BRUNSWICK STEAM ELECTRIC PLANT, UNITS 1 AND 2,  
INDIVIDUAL PLANT EXAMINATION  
TECHNICAL EVALUATION REPORT  
(FRONT-END)

SEA 92-553-028-A:3  
July 21, 1995

**Technical Evaluation Report  
on the Individual Plant Examination  
Front End Analysis**

NRC-04-91-066, Task 28

Figure 2-1. Typical Data for Recovery of Offsite Power

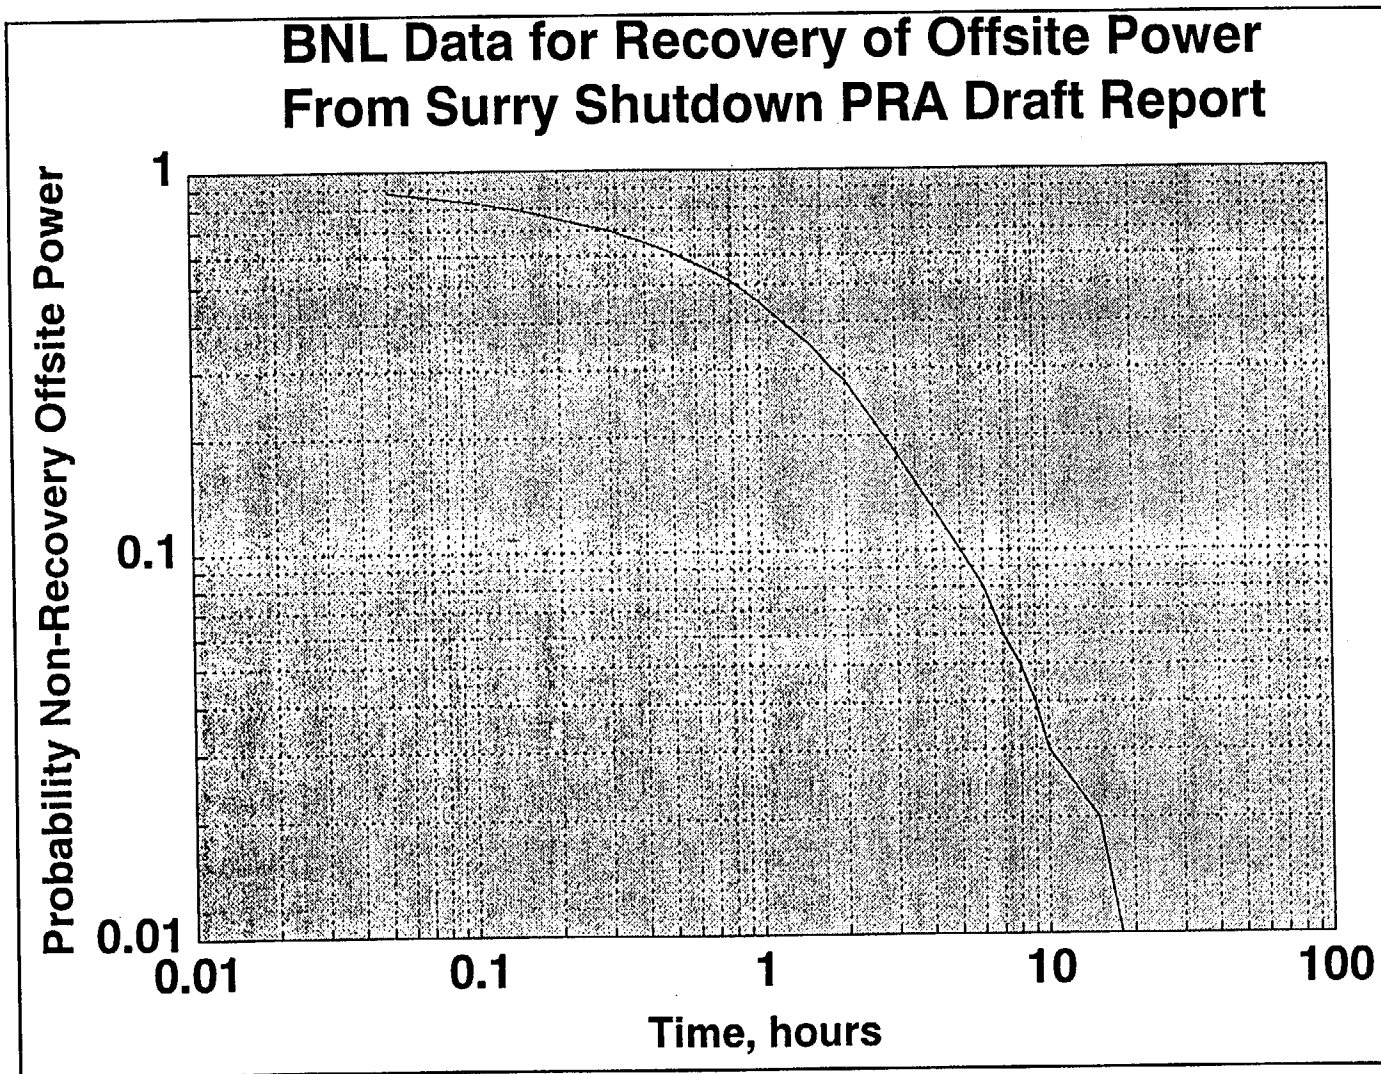
Typical data used for non-recovery of offsite power are given in Figure 2-1 of this report. Based on the data from this figure, the IPE values for non-recovery of offsite power are typical of other IPE/PRA studies.
